**RE: Nichols Ranch In Situ Recovery Mining Permit Application,
TFN 4 2/284**

To: File, Uranerz Energy Corporation's Nichols Ranch ISL Project, TFN 4
2/284

Subject: Second Consolidated Technical Reviews

Figure 22.36. There are several construction plans used in in-situ mining: (a) five-spot pattern, (b) seven-spot pattern, and (c) line-drive pattern. Distances vary between each well, although 50 ft (15.2 m) is typical.

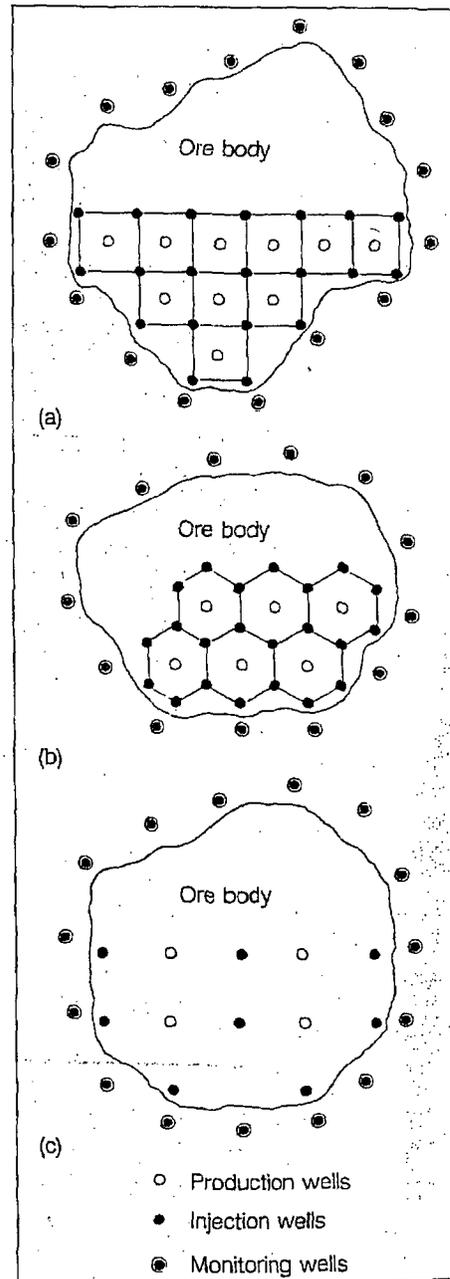
- 108-M.Mine Plan, Section 3.3.5, Proposed Injection Procedure, pg. MP-12, para.1, sent.3: For clarity Uranerz should consider revising Figure 3-3 to illustrate the entire wellfield construction layout that may be used. (see attached Figure 22.36 from Groundwater and Wells, Driscoll, 1986, pg. 774). (MT)
